SERVICE BULLETIN CHANGE NOTICE

S.B. No. A320-21-1037

TITLE: AIR CONDITIONING-PACK TEMPERATURE CONTROL-

MODIFY PACK RAM INLET

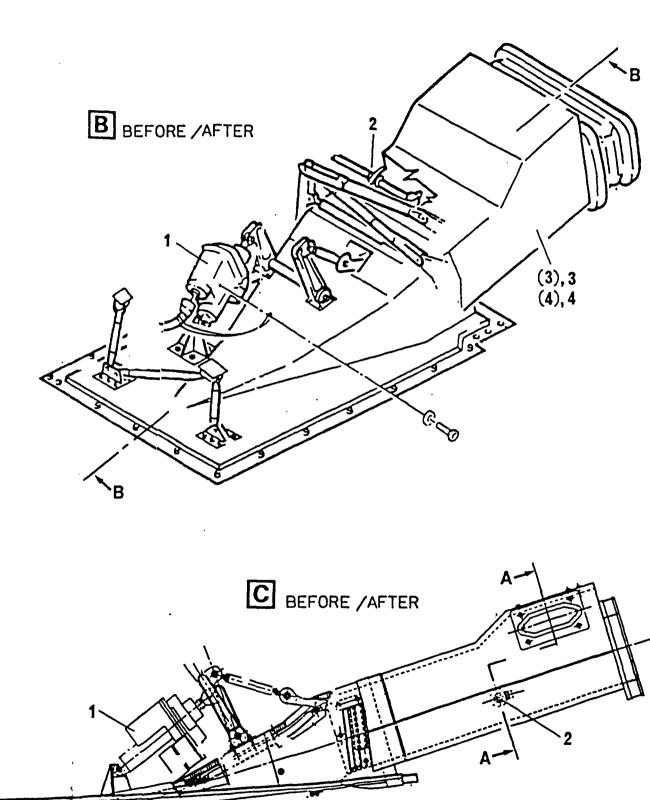
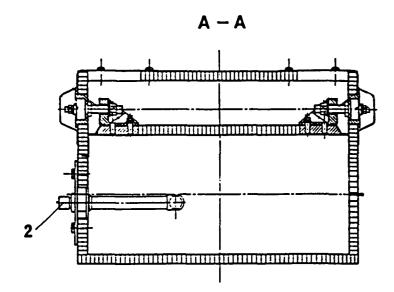
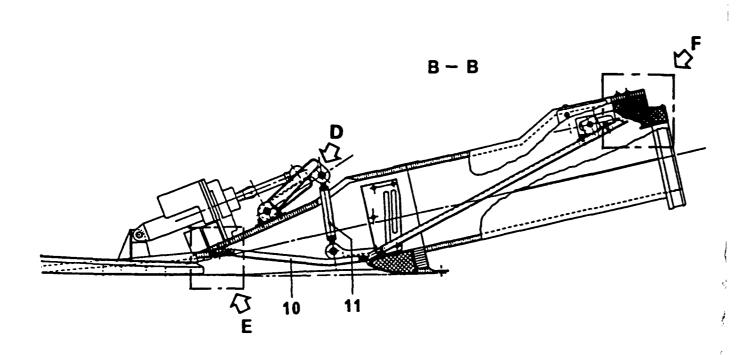
(1) Removal and Installation of the pack ram air inlets.

Refer to Figure 1, Sheet 1 of 2

- (a) Disconnect the water hoses from the water injectors 20HM and 21HM, item 2 (Ref. AMM 21-61-51, P. Block 401 and 21-52-42, P. Block 401).
- (b) Electrically disconnect the air inlet flap actuators 8HH and 28HH, item 1 (Ref. AMM 21-61-51, P. Block 401).

- (c) Remove the pack ram air inlets, item (3) and (4) (Ref. AMM 21-61-51, P. Block 401) from the aircraft for modification on bench.
- (d) Install the modified pack ram air inlet, LH D21571101008000, item 3 and the pack ram air inlet, RH D21571100004000, item 4 (Ref. AMM 21-61-51, P. Block 401).

- (e) Electrically re-connect the air inlet flap actuators 8HH and 28HH, item 1 (Ref. AMM 21-61-51, P. Block 401).
- (f) Re-connect the water hoses to the water injectors 20HM and 21HM, item 2 (Ref. AMM 21-61-51, P. Block 401 and 21-52-42, P. Block 401).

Modification of the Pack Ram Air Inlet, LH and RH Figure 1, Sheet 2 of 2

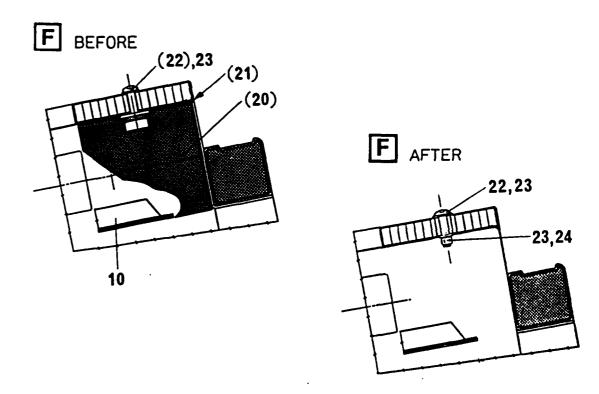
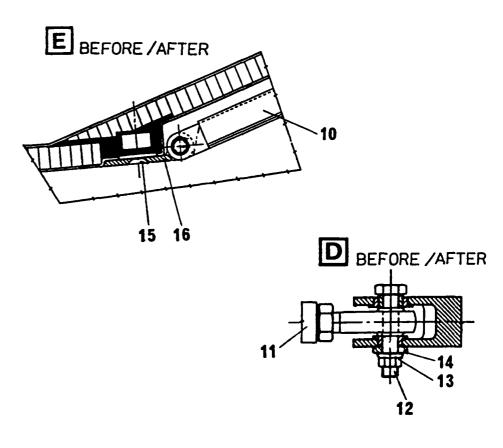
(1) Removal of filler from the ram air inlet.

Ref. Figure 1, Sheet 2 of 2

(a) For disconnecting the rod, item 11, remove and retain these items:

- (b) For loosening the diffuser ramp, item 10 with hinge, item 16 at the lower side (see detail E) remove and retain the screws, item 15.
- (c) Move down the diffuser ramp, item 10 at the hinge, item 16. At the same time pull the rod, item 11 so that the diffuser ramp moves out of the filler area, ref. detail F.
- (d) Remove and do not re-use the filler, item (20) with these items:

screw	item (22)	(not re-used)
washer	item 23	(retain)
shim	item (21)	(discard)

(e) Install these items to seal the holes, ref. detail F:

NAS1100E08-12 AN960C8	item 22 item 23	(new) (new and
			retained)
nut	MS21042-08	item 24	(new)

(f) Fasten the Loosened diffuser ramp, item 10 with these items, ref. details E and D:
